Safety Recall Trucks

Date	Group.	No.	Page
04.12	SC0360		1(3)

Move Alternator Ground Cable, Compressed Natural Gas (CNG)

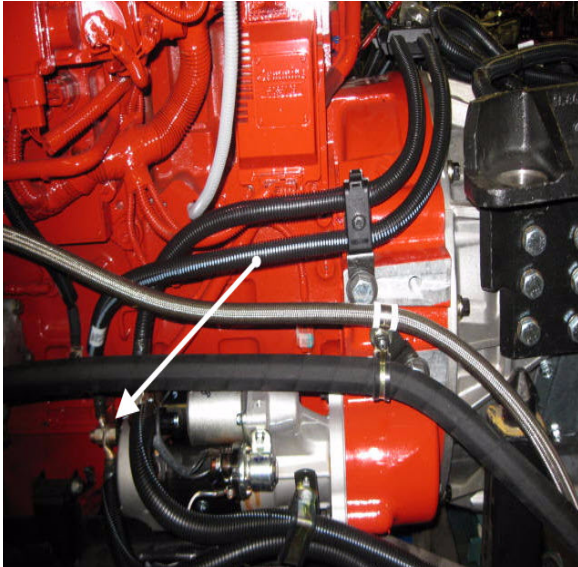
On these vehicles, the alternator ground cable runs directly to the starter and bypasses the fusible link. To correct the issue, remove the alternator ground cable from the starter and install the cable onto the engine ground stud.

1. Disconnect all cables from the negative (ground) battery terminals to prevent personal injury from electrical shock and damage to electrical equipment.
2. Raise the cab.
3. Locate the starter on the left side of the engine.
4. Remove the ground cable at the rear of the starter (routed from the alternator).

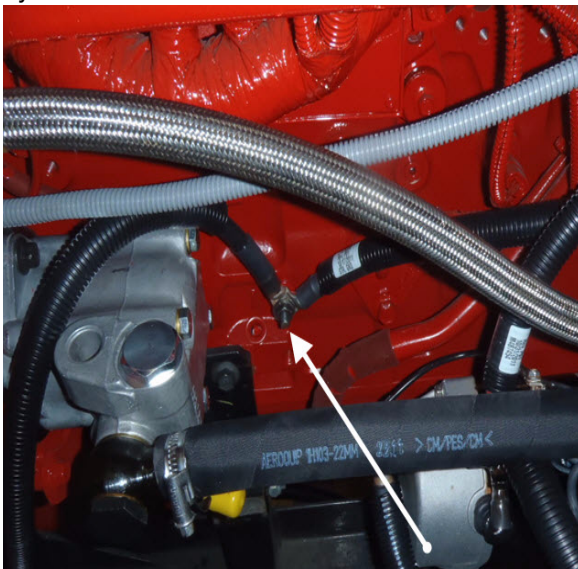
5. Torque starter ground stud to 26 +/- 1.5 Nm (19.2 +/- 1.1 ft-lb).
6. Loosen the engine ground stud.
7. Install the alternator ground cable onto the ground stud (located on the side of the engine block).

NOTE: Place the alternator ground cable behind the existing cable to allow sufficient support for the terminal ring eye.

8. Torque the engine ground stud to 19 +/- 1 Nm (14 +/- 0.7 ft-lb).
9. Lower the cab.
